In-Vessel Inspection Before Head Removal: TMI II Phase II (Tooling and Systems Design)

D. W. Greenlee

July 1981

B&W'S RESPONSE TO COMMENTS ON
IN-VESSEL INSPECTION BEFORE HEAD REMOVAL
(PHASE II REPORT)

Figure 1.2 GENERAL APPROACH

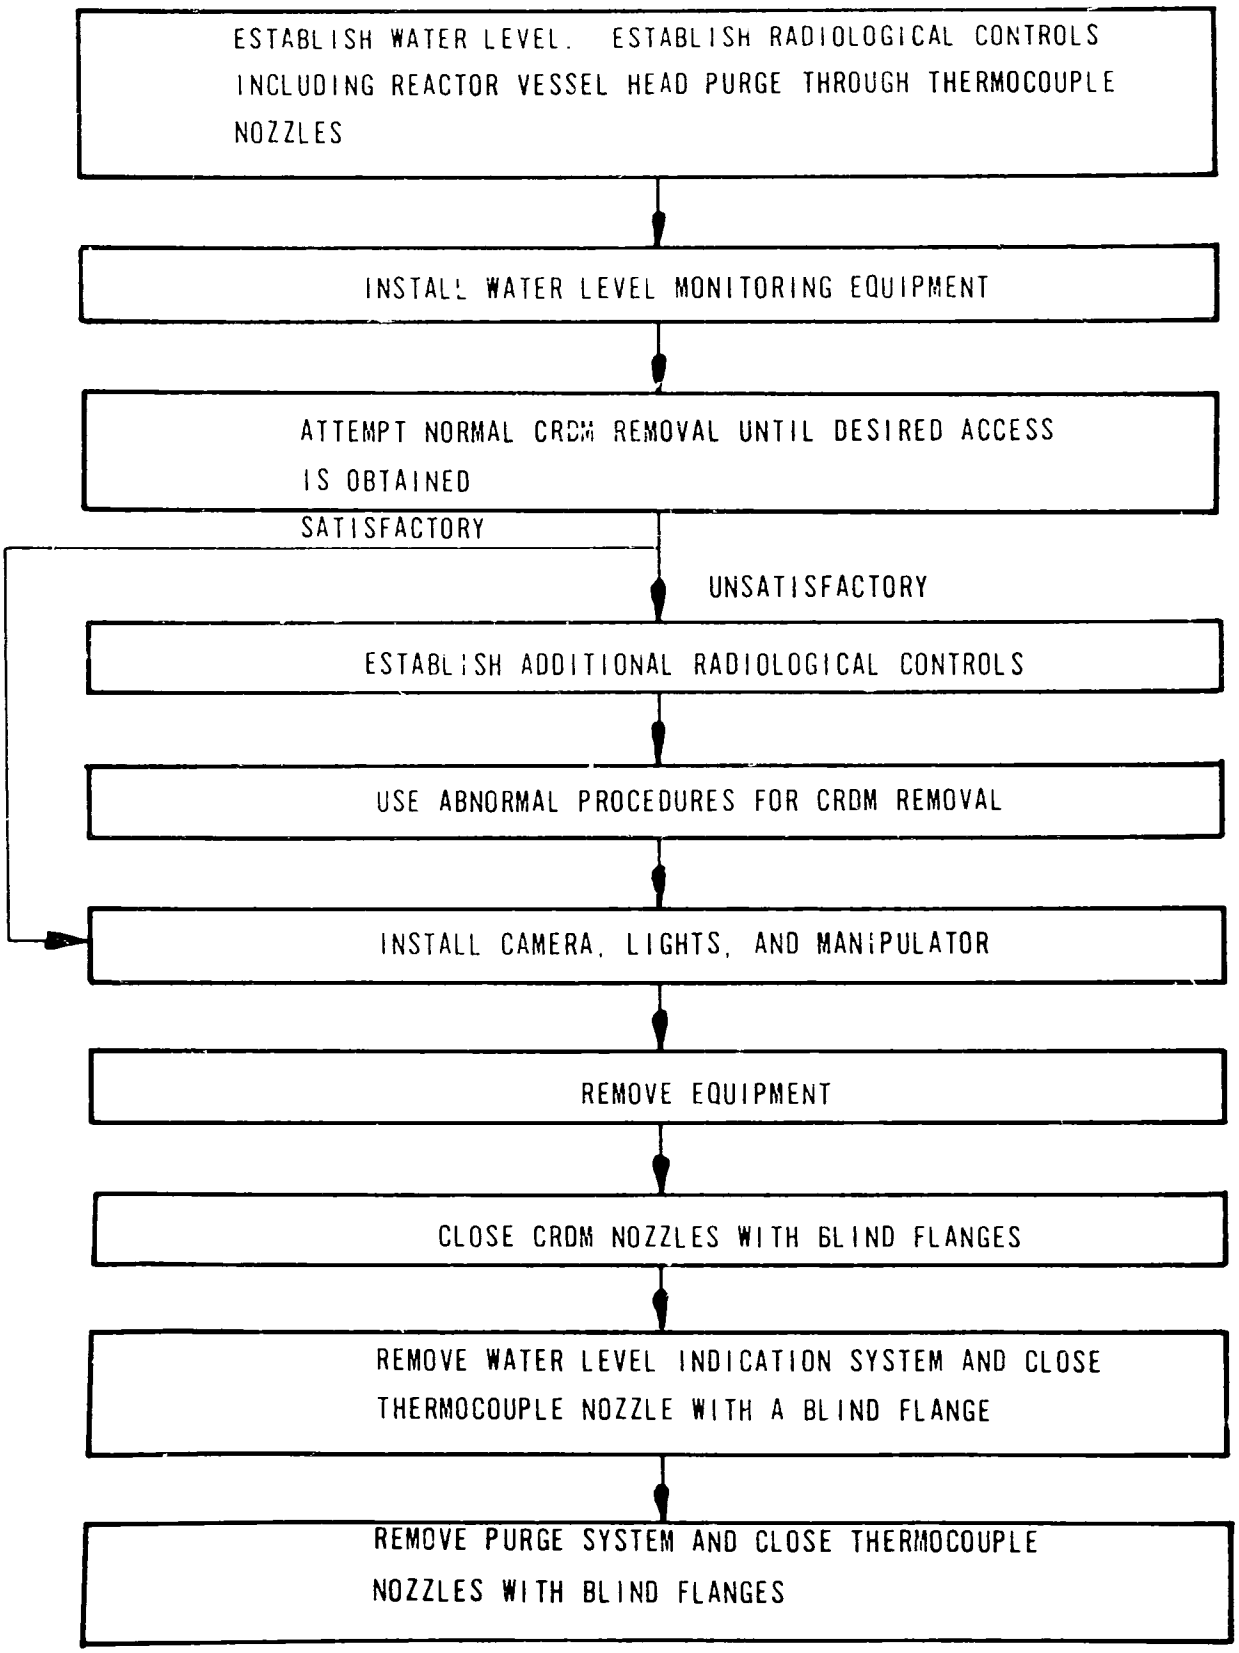
2. Figure 1-2, General Approach (block diagram) is incomplete. No reference to dummy flange covers, dummy nozzles, etc.

Ans. Figure 1-2 has been changed to include these items.

Figure 4.4 SPECIAL LEADSCREW LIFTING TOOL

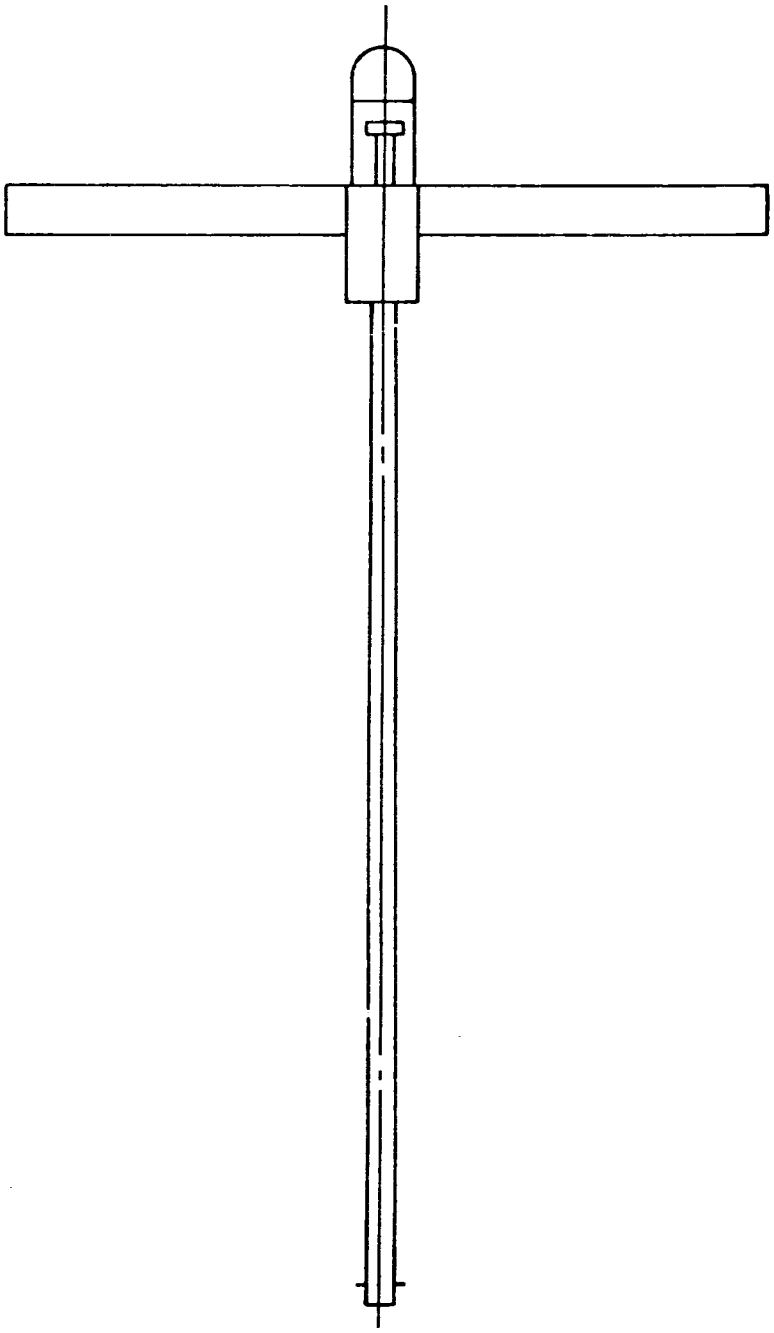
19. The leadscrew holding tool shown in Figure 4.4 will bind as soon as the tool arms move.

Ans. Figure 4.4 was only a concept.

FIGURE 6.2 MURKY WATER MANIPULATOR

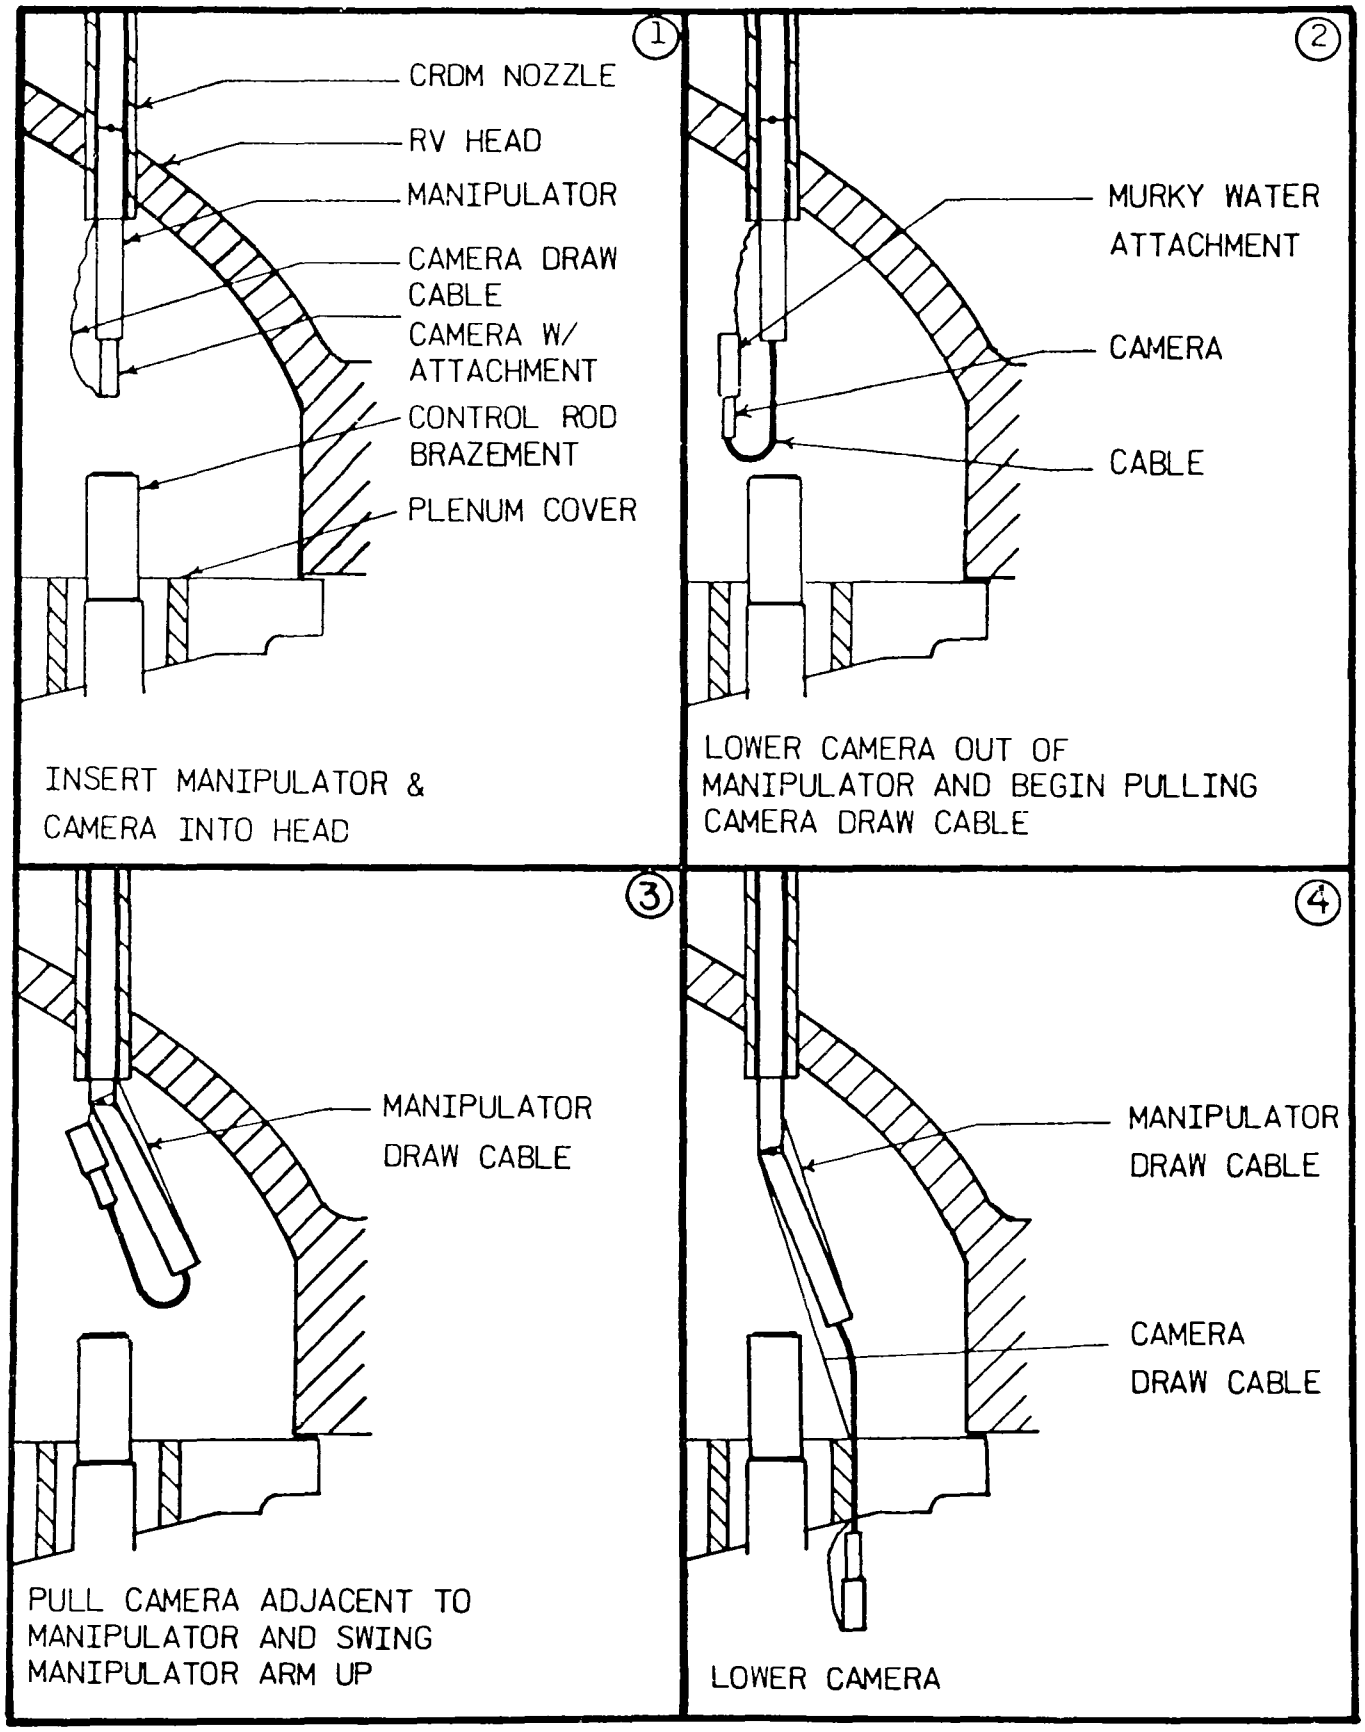
6. Murky Water Viewing Attachment - No answers to previous questions and comments from Phase I review; technique not tested with complex parts like the top of a fuel assembly with a spider in it; 2-5/8 in. diameter housing won't fit in camera manipulator (interface with articulation swing clearance)?

Ans. B&W's intended procedure for manipulating the murky water viewing equipment under the reactor head is described on Figure 6.2 in the revised report.
